ADMINISTRATIVE AMENDMENT

FEBRUARY 16, 2023
 MINOR AMENDMENT - ON STREET PARKING SPACES RELOCATED FROM JACKSON ST. TO THE PROPERTY, ENTRY GATES SHIFTED NORTH TO ACCOMMODATE RELOCATED ACCESSIBLE PARKING.

PROJECT NAME
HILAND PLAZA

SHEET TITLE
**SITE PLAN
 DRB**

A1 LANDSCAPE PLAN
SCALE: 1"=20'-0"

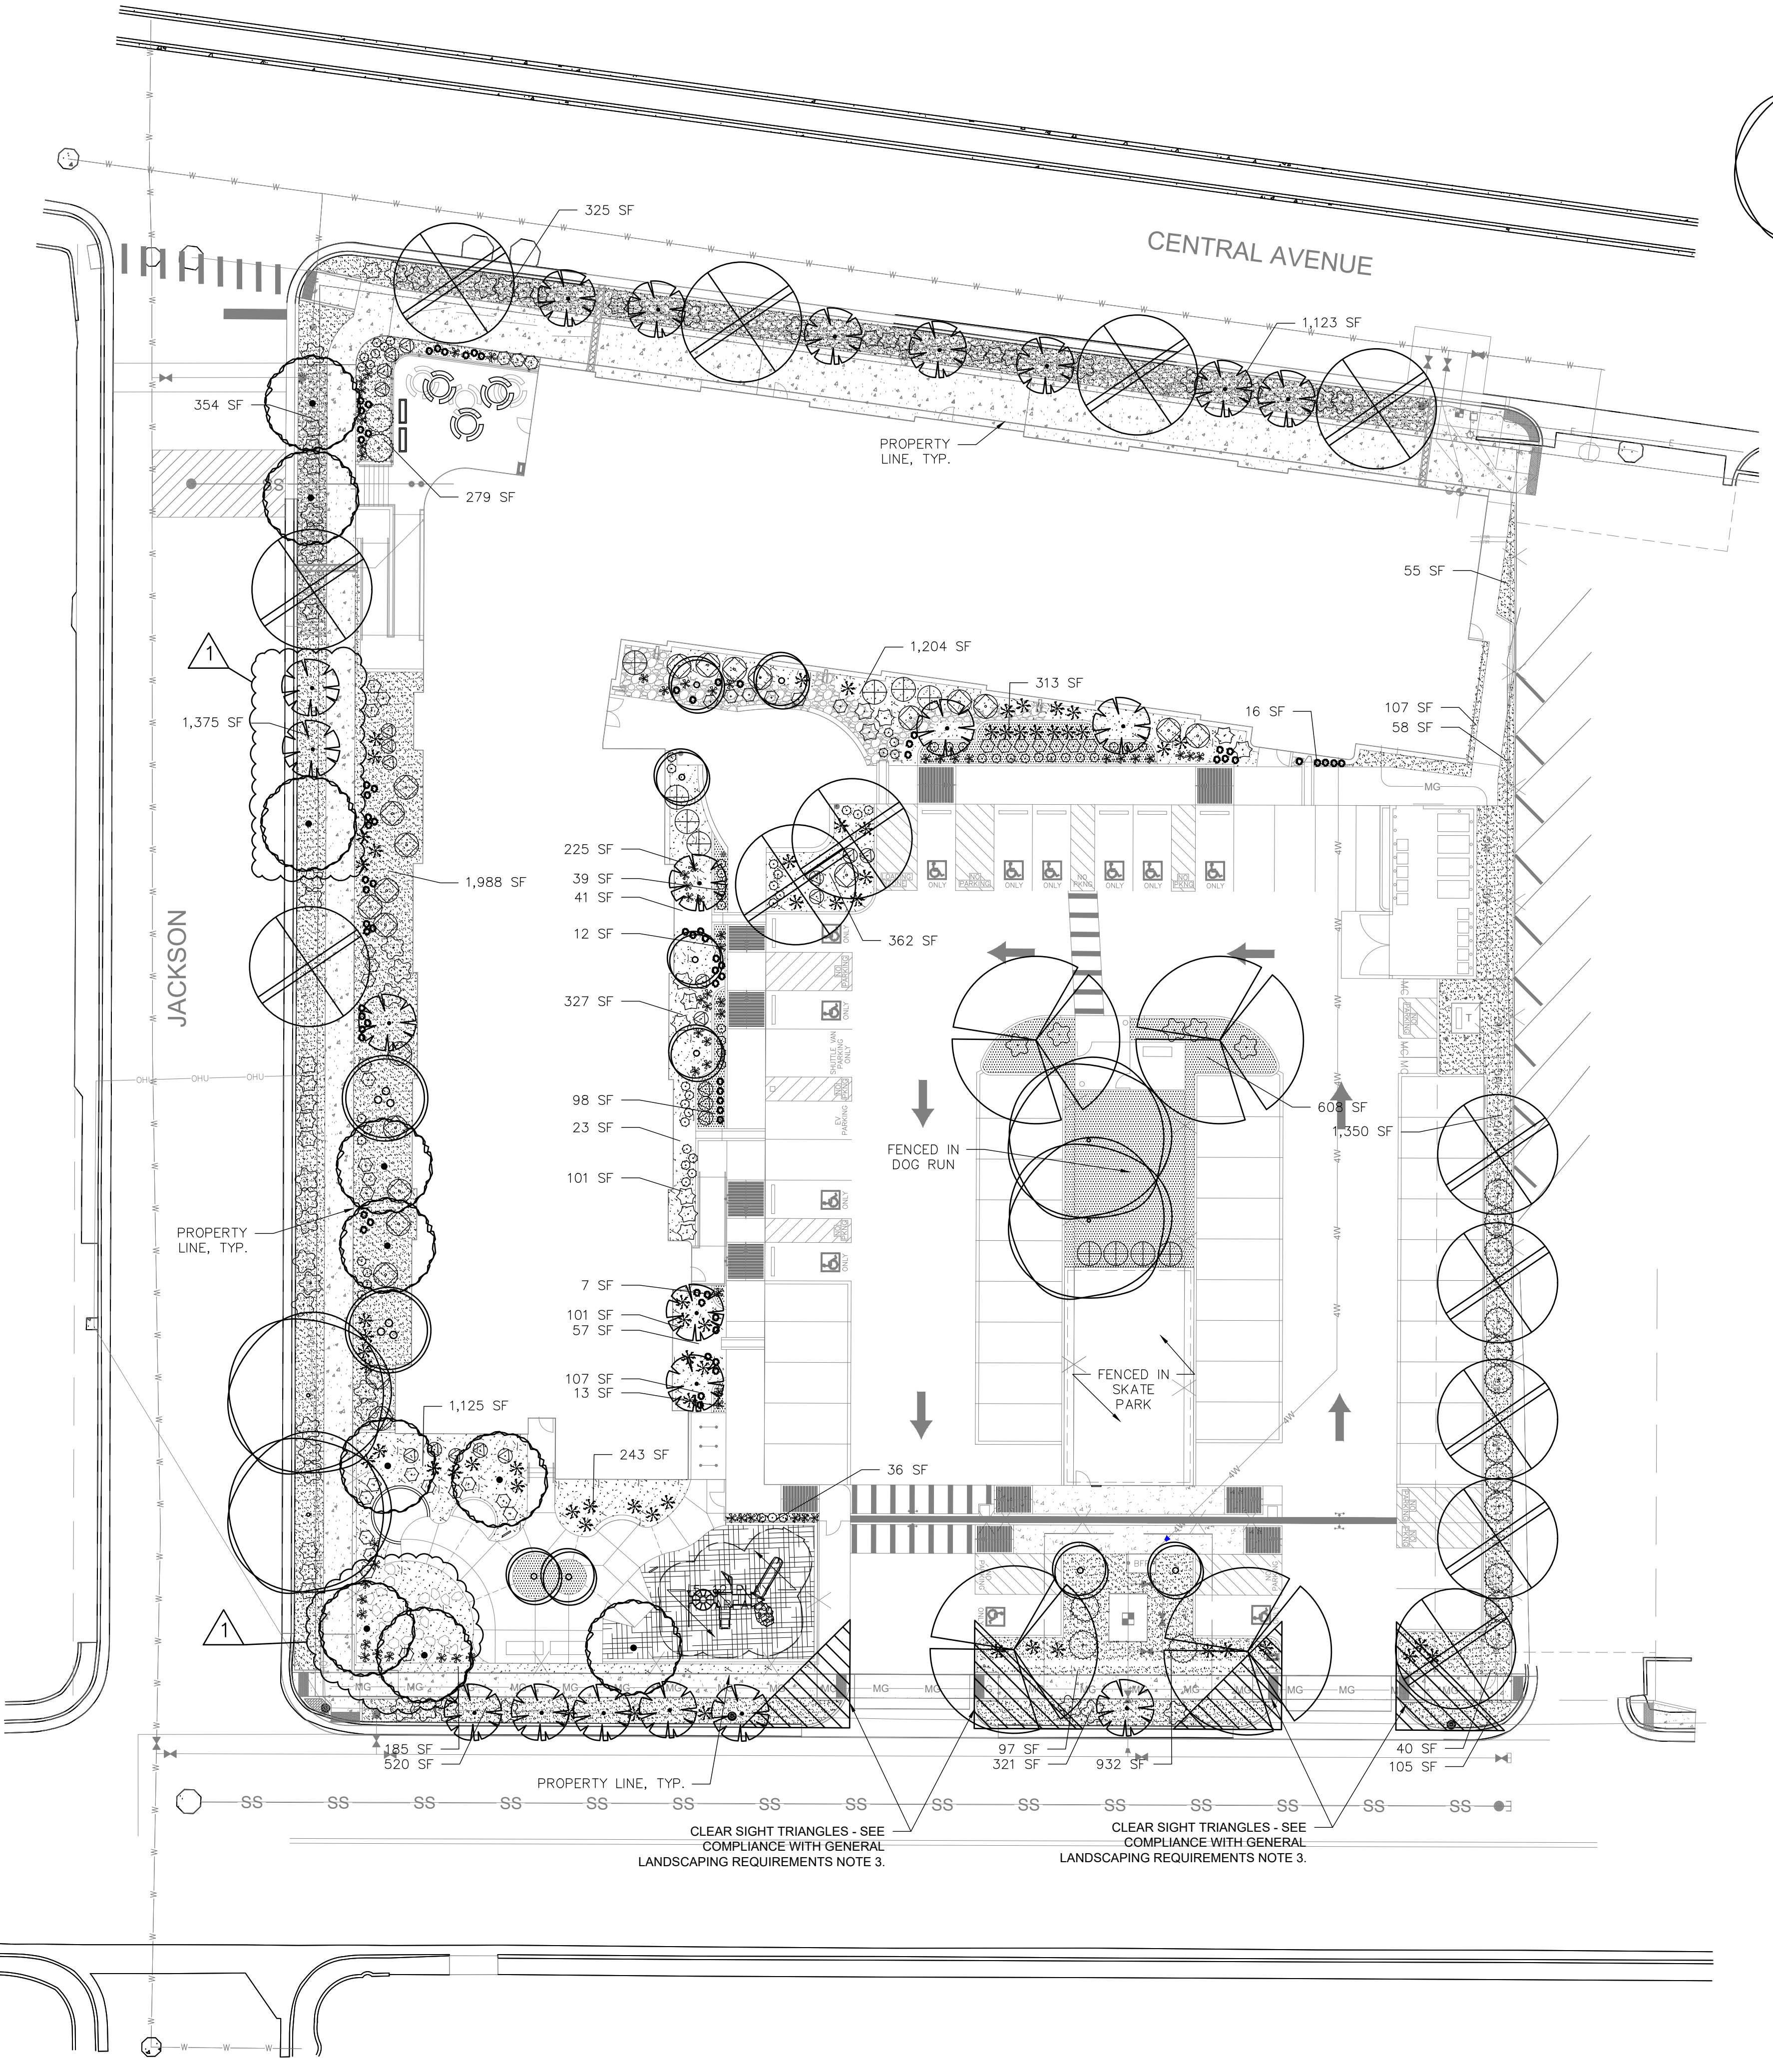
FEBRUARY 16, 2023
MINOR AMENDMENT
LANDSCAPE PLAN CHANGES PER SITE PLAN
